REMARKS

In response to the Office Action mailed March 31, 2002, claims 1, 5 and 6 have been amended. Claims 1-15 remain pending. Reconsideration of the application is respectfully requested.

Application No. 09/960,606

ATTACHMENT
REDLINED AMENDMENT

Fig. 8

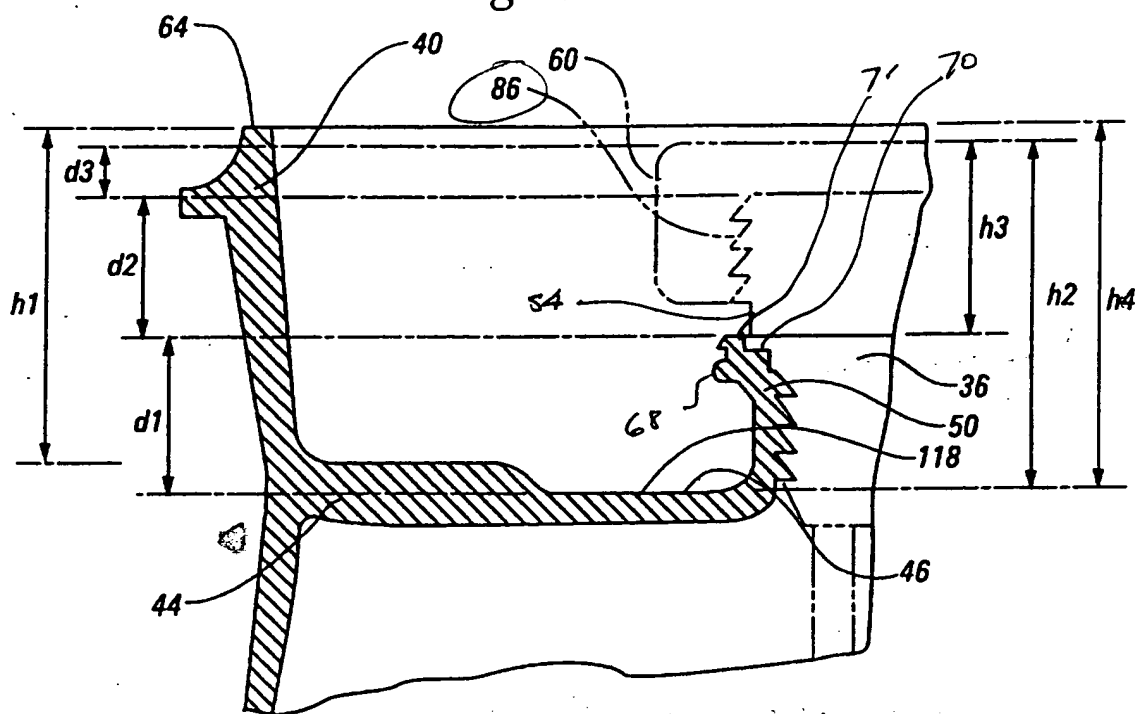
Various amendments to the specification and Figures 8 and 9 of the drawings have been made to correct typographical errors and to further clarify the claimed invention. No new matter has been introduced by these amendments.
